**RE: REQUEST FOR FURTHER INFORMATION SD22B/0261
22A MAIN ROAD, TALLAGHT, DUBLIN 24.**

As per South Dublin County Council F.I request dated 28th July 2022 in relation to the above named application, we wish to respond as follows,

Photo A1 (Looking to the East)

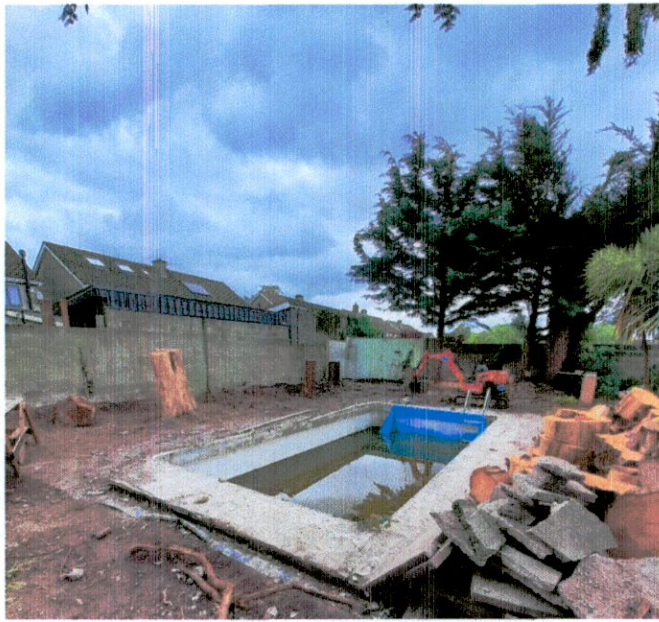
(a) The applicant is requested to provide a survey of the existing trees in close proximity to the proposed structure. The applicant should demonstrate the need for removal of any such trees, or the need for any root barriers and root protection measures to (a) protect the structure from nearby trees, and (b) ensure the works do not result in unintended loss of trees. Section drawings should be provided as appropriate. (b) The applicant is requested provide a proposed replanting schedule to show how the ecological features on the site can be restored or enhanced, and any losses mitigated against. (c) The applicant is requested to reconsider the siting or scale of the structure; a shift away from the rear boundary may significantly ease the construction and protection of the structure and trees.

Prior to our engagement with this project, much of the existing planting to the rear garden had already been removed during a general clearing of the property immediately after its purchase in early 2022. The main reason behind our client's decision to do so was due to the overbearing nature of many of the existing shrubs/trees which cast substantial shade in not only our client's site but also in each of the adjoining gardens. It is proposed that the new planting is more suitable to a Suburban garden than what it replaces, and due to its lesser height even after maturing will have less of a visual impact on the Client's property and those of their neighbours. (Please see landscaping Plan P4A)

The location of the Pool Room structure is dictated largely by the position of the existing pool which there is no changes proposed to as part of the application. We also note that the adjoining garden at the rear of the site (17 Bancroft Park), has an existing storage structure immediately next to the rear garden wall and so the similar positioning of the Pool Room is both most practical and wholly sympathetic to neighbouring properties.

Please see Photo A1, A2, A3 and Drawing P4A

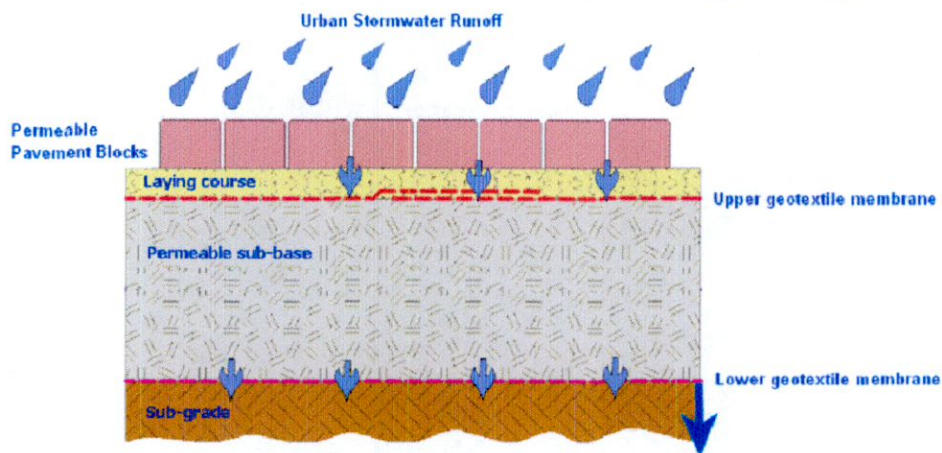
5. The applicant should submit details of any proposed soakaway including soil percolation test results, design calculations and dimensions for the proposed soakaway. The applicant should submit a report showing site specific soil percolation test results and design calculations for the proposed soakaway in accordance with BRE Digest 365 – Soakaway Design. The applicant should submit a revised drawing showing plan and cross-sectional views, dimensions, and location of proposed soakaway. Any proposed soakaway shall be located fully within the curtilage of the property and shall be: i) At least 5m from any building, public sewer, road boundary or structure. ii) Generally, not within 3m of the boundary of the adjoining property. iii) Not in such a position that the ground below foundations is likely to be adversely affected. iv) 10m from any sewage treatment percolation area and from any watercourse / floodplain. v) Soakaways must include an overflow connection to the surface water drainage network. Should a soakaway prove not to be feasible, then the applicant should submit the following: a) Soil percolation test results demonstrating a soakaway is not feasible b) A revised surface water layout drainage drawing for the development showing the inclusion of alternative SuDS (Sustainable Drainage Systems) features.

No soakaways are proposed for the site. There is no history of the site suffering from flooding and with the addition of Rainwater Butts to downpipes servicing the additional roof structures we believe the existing mains drainage servicing the site will remain sufficient.
